Access Compliance Report

Public Rights-of-Way

(Curb Ramps)

Intersection ID: 31889	Main Street: MT_MANSFIELD_RD	Cross Street: SPRUCE_PEAK_RD	Location: SW
ADA ID: 3201422F9A08	Ramp Type: PerpDiag	Initial Pass/Fail: Fail	Overall Compliance: No
Severity Score: 8.75			
Codes/Mitigation Info/Possible Solution		Field Measurements/Component Compliance

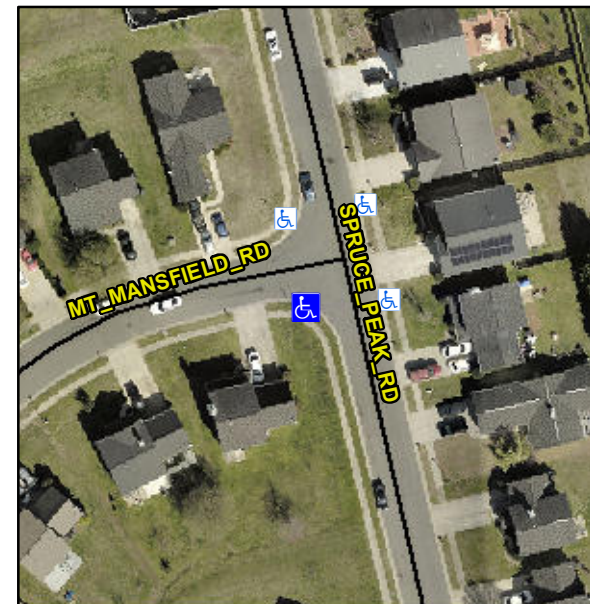
R304.5.1

Compliance	Description	Data	Compliance	Description	Data
N/A	Ramp Length (in)	48.0	Yes	Ramp Slope (%)	7.7
No	Ramp Width (in)	39.0	Yes	Ramp XSlope (%)	1.6
N/A	Flare Type LT	N/A	N/A	Flare Type RT	N/A
N/A	Flare Slope LT (%)	N/A	N/A	Flare Slope RT (%)	N/A
N/A	Flare Traversable LT?	N/A	N/A	Flare Traversable RT?	N/A
N/A	Landing Length (in)	N/A	N/A	DWS Provided?	N/A
N/A	Landing Width (in)	N/A	N/A	DWS Contrast?	N/A
N/A	Landing Slope (%)	N/A	N/A	DWS Length (in)	N/A
N/A	Landing X Slope (%)	N/A	N/A	DWS Full Width?	N/A
N/A	Landing Curb? (Y/N)	N/A	N/A	DWS Offset (in)	N/A
N/A	Shared Landing?	N/A			
N/A	Gutter Ponding?	N/A	N/A	Gutter Slope (%)	N/A
N/A	Gutter Lip Ht (in)	N/A	N/A	Gutter X Slope (%)	N/A
N/A	Painted X Walk1?	No	N/A	Painted X Walk2?	No
	X Walk 1 Direction	To E		X Walk 2 Direction	To N
N/A	X Walk 1 Width (in)	N/A	N/A	X Walk 2 Width (in)	N/A
	X Walk 1 Slope (%)	4.2		X Walk 2 Slope (%)	3.1
	X Walk 1 X Slope (%)	2.1		X Walk 2 X Slope (%)	1.9

N/A	Ramp inside XWalk1?	N/A	N/A	Ramp inside XWalk2?	N/A
	Road Slope (%)	1.0	N/A	Clear Space?	N/A
	Road X Slope (%)	5.4	N/A	Clear Space to XWalk (in)	N/A
N/A	Any Obstructions?	N/A	N/A	Storm Grate/Utility Hazard?	N/A
	Obstruction Type			Storm Grate/Utility Type	
		N/A			N/A
		Yes		Surface Condition? (G/P)	Good

Remove & Replace Curb Ramp With Two New Directional Ramps or Equivalent.
